RE: DENDROBIUM MINE – RESPONSES TO DAMS SAFETY NSW SUBMISSION ON EIS

RESPONSES TO DAMS SAFETY NSW SUBMISSION ON EIS

Figure 1

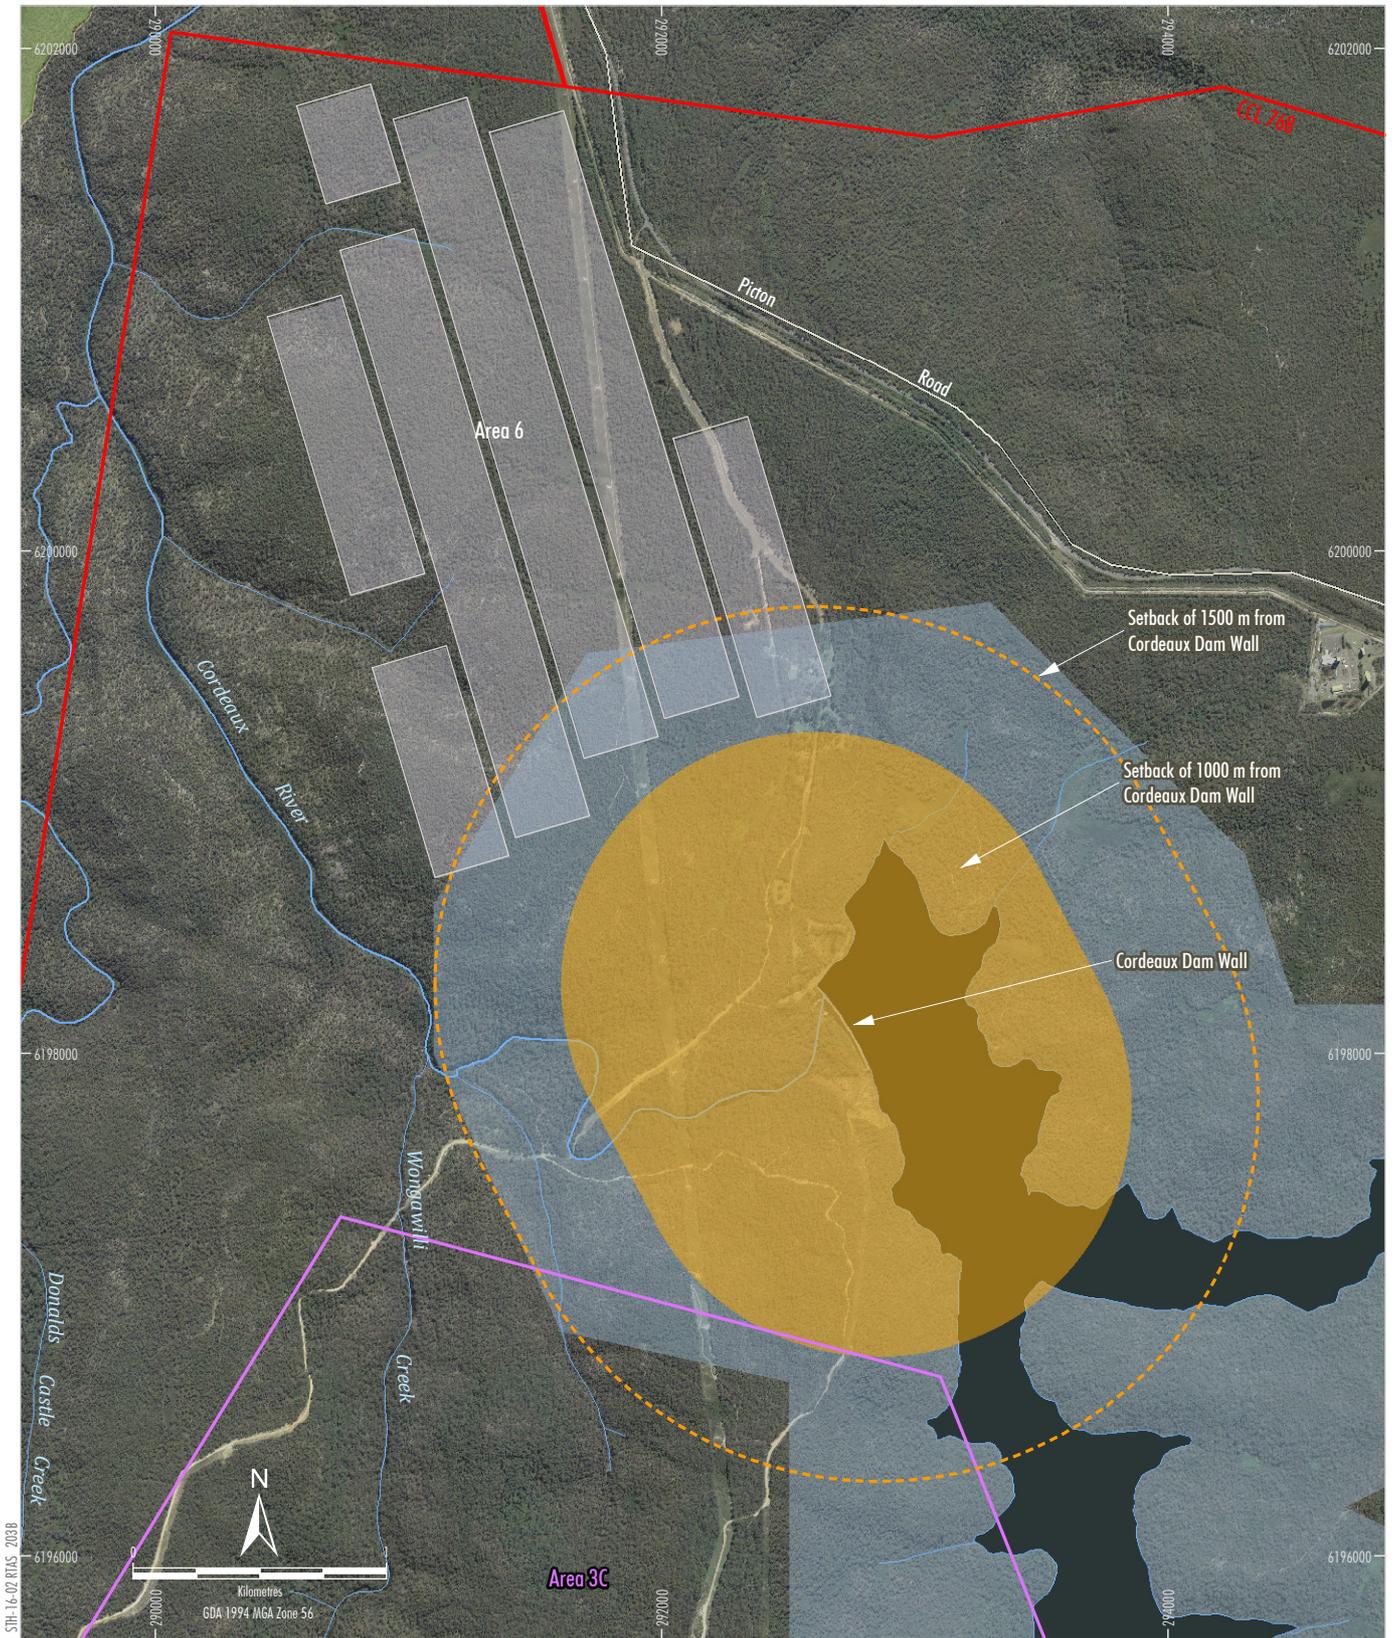
To reduce the likelihood of cracking the dam walls, longwall extraction should approach no closer than 1,500 m to the dam walls.

An assessment by an appropriately qualified Dams Engineer is required to determine if the longwalls should be moved further away from the dam walls.

South32's existing commitment regarding setbacks of secondary extraction from dam walls is "*setbacks from the Avon and Cordeaux dam walls to the Project longwalls by a minimum distance of 1,000 m*" (Section 6.6.3 of the Submissions Report). As described above, the intention of this setback was the protection of the dam walls (i.e. the Project is not seeking approval to damage the dam walls) (Figures 1 and 2).

Notwithstanding, a minimum setback distance was developed to inform the Project mine design and assessment. The minimum setback distance of 1,000 m was selected based on the previous longwall setbacks adopted at the Dendrobium Mine and on the conclusion of MSEC (2019) that predicted differential subsidence movements are unlikely to be measurable at this distance.

Figure 1 Measured incremental far-field (absolute) horizontal movements at Dendrobium Mine and elsewhere in the Southern Coalfield (Source: Fig. 4.4 from MSEC, 2019)

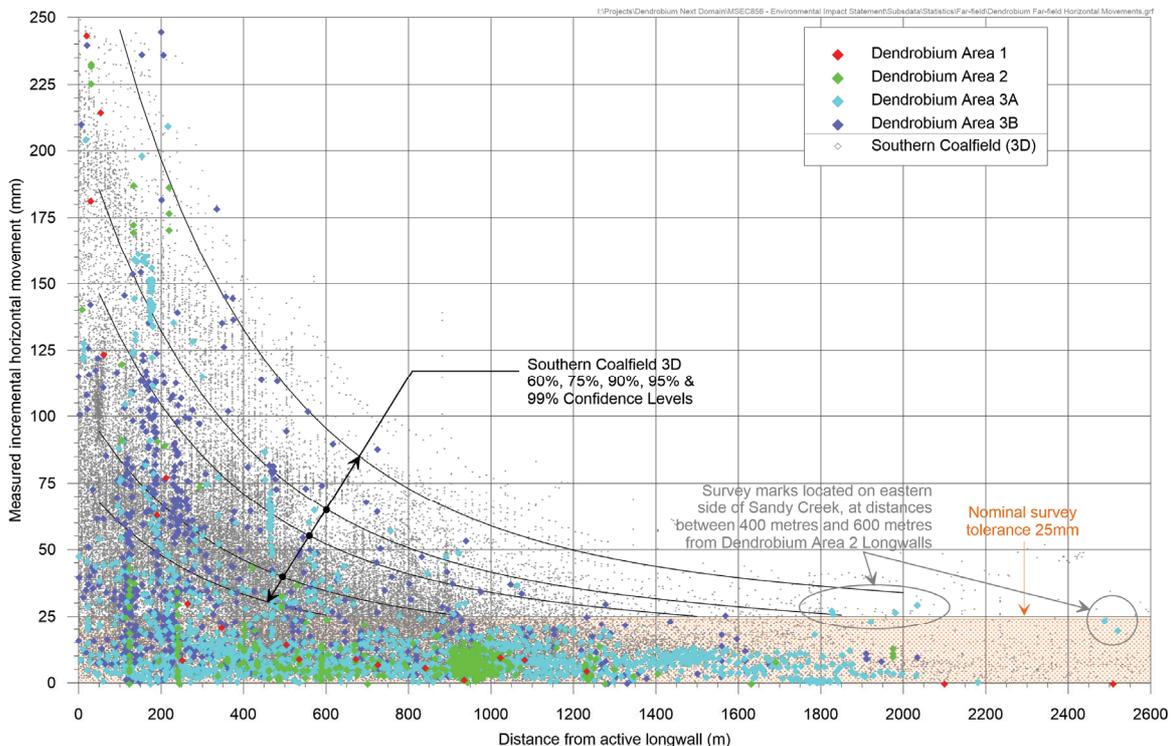
This statement that there is "a potential to elongate the dam wall by 120 mm" is not correct. The chart referred to by DSN shows absolute horizontal movements rather than differential movements due to mining. Further detail is provided below.

The far-field horizontal movements measured at Dendrobium Mine are shown as the red, green, cyan and blue diamonds in Figure 1. At distances of 1000 m or greater from the extracted longwalls at the mine, the majority of the measured far-field movements (i.e. 98 % of cases) are less than the nominal survey tolerance of 25 mm for absolute position. The survey tolerance for far-field horizontal movements is greater than that for other subsidence parameters, such as strain, as it is measured using GPS. In a small number of cases, far-field horizontal movements greater than the nominal survey tolerance have been measured at distances of 1000 m or greater, in the order of 25 mm to 60 mm.

The far-field horizontal movements measured elsewhere in the Southern Coalfield are shown as the grey diamonds in Figure 1 for comparison. At distances of 1000 m or greater from the extracted longwalls, the movements measured at Dendrobium Mine are less than those measured elsewhere in the Southern Coalfield. The reason is the shallower depths of cover at Dendrobium Mine result in greater subsidence effects directly above the mining area but lesser effects further afield outside the mining area.

Figure 2 Measured total valley closure versus distance from nearest longwall (Source: Fig. 6.17 from MSEC, 2019)

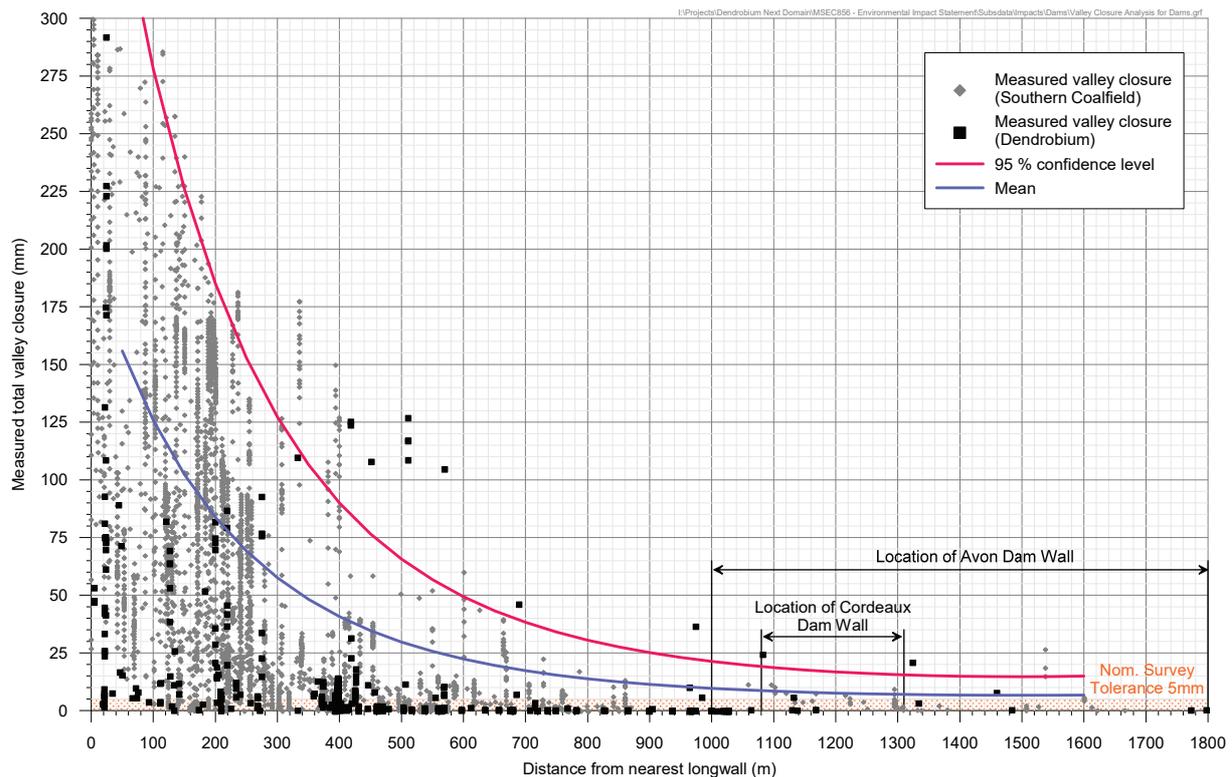
Adding extraction of longwalls in Area 3C, at a similar time to extraction of Area 6, increases the potential movement at the Cordeaux dam wall. Area 6 is north of Cordeaux Dam wall while Area 3C is south of the Cordeaux Dam wall. At 1000m distance from the dam wall (as proposed by South32) to each extraction area, the far field horizontal movement is 60mm towards each area (from chart above). That is, a potential to elongate the dam wall by 120mm. The potential for this amount of movement has not been addressed by the MSEC report.

The valley closure movements measured at Dendrobium Mine are shown as the black squares in Figure 2. At distances of 1000 m or greater from the extracted longwalls at the mine, the majority of the measured valley closure movements (i.e. 93 % of cases) are less than the nominal survey tolerance of 3 mm to 5 mm. Valley closures of 20 mm to 35 mm have been measured at the Wongawilli Creek C-Line after the mining of LW9 to LW11 in Area 3B; however, these values include the measured movements due to previous mining in Area 3A at a minimum distance 370 m. Excluding this monitoring line, the maximum valley closure movement measured at distances of 1000 m or greater at Dendrobium Mine is 8 mm.

The valley closure movements measured elsewhere in the Southern Coalfield are shown as the grey squares in Figure 2 for comparison. At distances of 1000 m or greater from the extracted longwalls, the majority of the measured valley closure movements (i.e. 89 % of cases) are less than the historic survey tolerance of 5 mm to 10 mm. The historic survey tolerance is greater as the monitoring data from the Southern Coalfield includes older surveying techniques. Some data also appear to include results where survey prisms have been disturbed.

Figure 3 Measured accumulated opening and closure for the Avon Dam closure lines (Source Fig. 2.3 of MSEC, 2020)

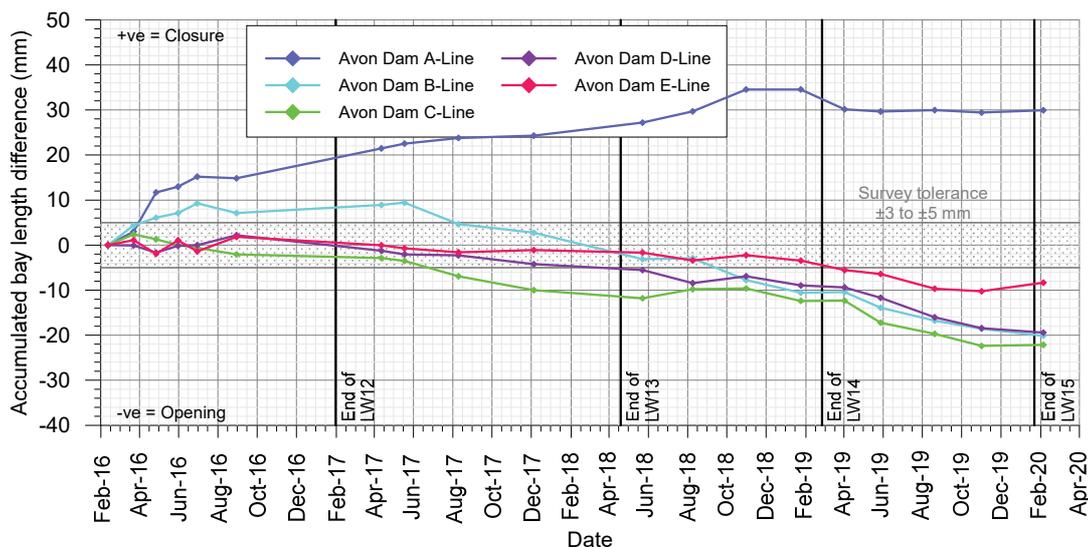
Uplift on the valley floor below the dam walls has not been addressed. Movement of the valleys that Avon and Cordeaux are located in may be triggered by Basal Shear Planes and Far-Field Horizontal Movement. This potential for adverse movement of the dam foundations needs assessment of the likely impact to the dams.

Valley closure of 20 mm was initially measured along the Avon Dam A-Line during the mining of LW12 and increasing to 35 mm during the mining of subsequent longwalls. The northern end of this monitoring line is located 330 m from the commencing end of LW12. Closure was also initially measured along the Avon Dam B-Line during the mining of LW12, with its eastern end located 520 m from this longwall.
